### Technical Bulletin

No.: RM048001e

The items in bold italics have been corrected.					
Subject: Firmwar	Subject: Firmware Release Note: System Firmware Prepared by: Y.Gaman				
From: 2nd Overs	From: 2nd Overseas Tech Support Sec., 2nd PQM Dept.				
Classification:	Troubleshooting	Part informat	tion	Action required	
	Mechanical	Electrical		Service manual revision	
	Paper path	Transmit/rec	eive	Retrofit information	
	Product Safety	🛛 Other (	)	🛛 Tier 2

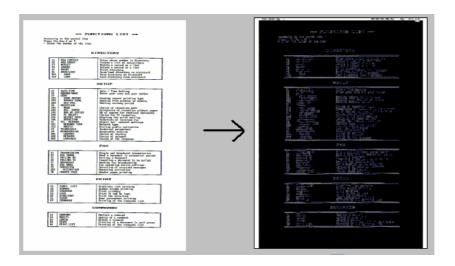
Under the following conditions, the background of a received fax appears black, as shown in the sample below:

- The fax is sent using Delayed Transmission (Memory Transmission)
- Contrast is set to "-----0" and Brightness set to "0-----".

The same Contrast and Brightness settings for the scanning engine are applied to both copier and fax images. However, fax images are one-bit binary, while copier images are multi-bit digital. When the Contrast and Brightness settings are set to their extreme values (limits), the fax image will appear as shown above.

Please do not set Contrast and Brightness to the settings described above when using Delayed Transmission (Memory Transmission).

### 2.Exterior 2 (M048/M049)

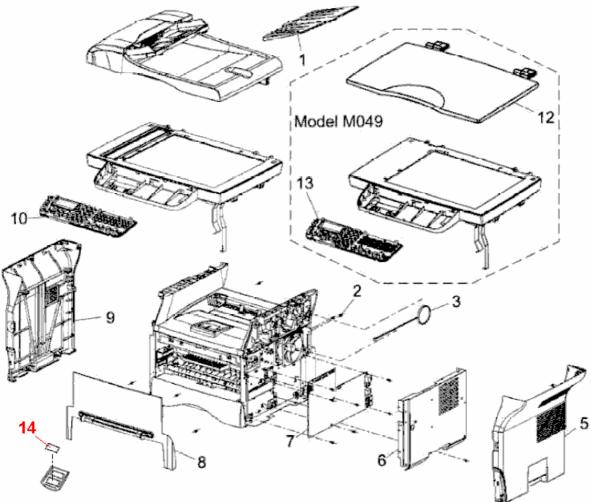
New part number	Description	Q'ty	Page	Index	Note
M0488634	DECAL:MODEL NAME PLATE:M048:LAN	1	5	14	Oceania only

This decal was added.

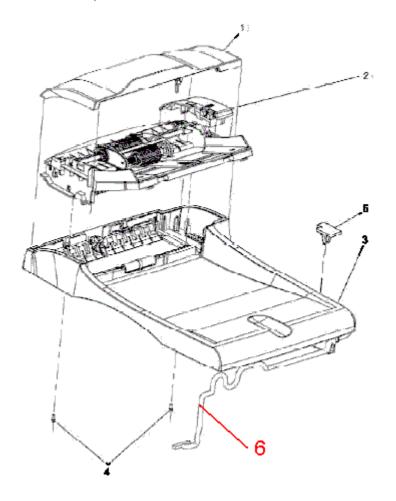
New part number	Description	Q'ty	Int	Page	Index	Note
M0481059	HARNESS:MOTOR & SENSOR	1	-	17	6

Change: This part was added.

**Reason**: Requests from the field.

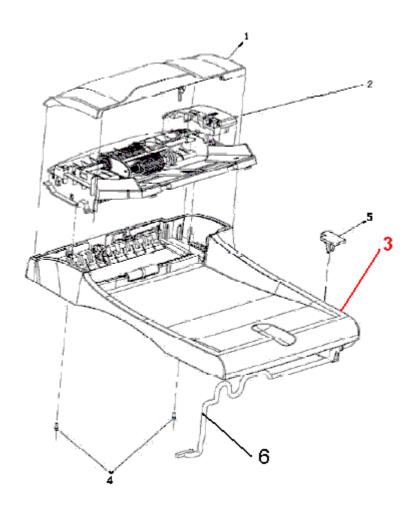
Incorrect part number	Correct part number	Description	Q'ty	Int	Page	Index	Note
M0481056	M0481057	ADF Exit Tray	1	X/O	17	3

**Change/Reason:** The part number listed in the Parts Catalog for the DF Exit Tray was corrected.

Electronic components to check

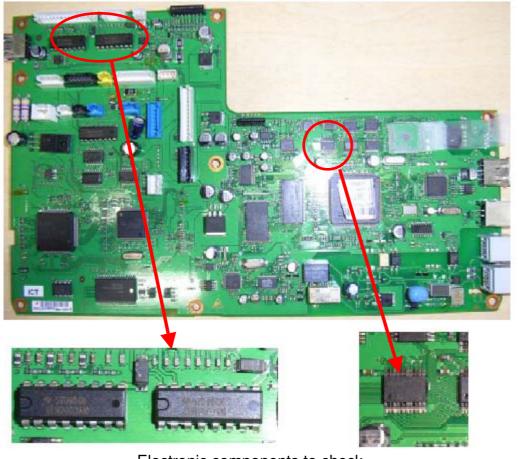
- 1. Check the elements of the main board for any damage (see the photos below).
- 2. If any of the elements are damaged, replace the ADF motor, the scanner motor, and the main board **together as a set**.

**Important:** If the elements appear normal, you do not need to replace these parts at this time. However if the symptom recurs later, replace these parts (two motors and main board) at that time, together as a set.

3. Upgrade the System firmware to **v2.07g** or newer.

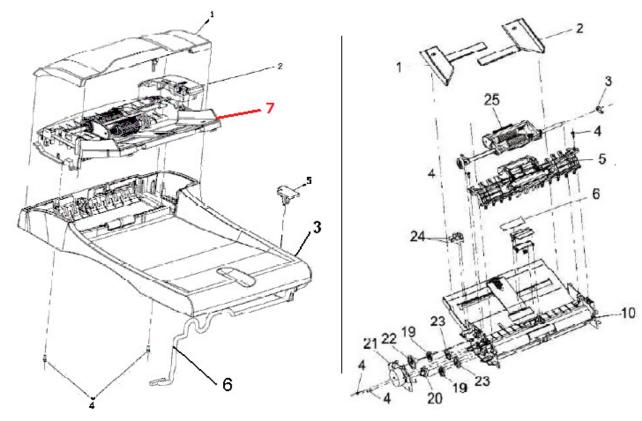
Old	New	Description	Q'ty	Int	Page	Index	Note
part number	part number						
M0489501	-	PAPER FEED ROLLER	1	X/O	19	25	
		ASS'Y:253240690					
-	M0489502	ADF PAPER FEED	1	X/O	17	7	
		ASS'Y					
		253017421:252970629

Change/Reason: Vendor change

Due to a vender change, Paper Roller Ass'y (Index 25) cannot be supplied any more. Please replace the assembly of M0489502 (New Index 7) instead.
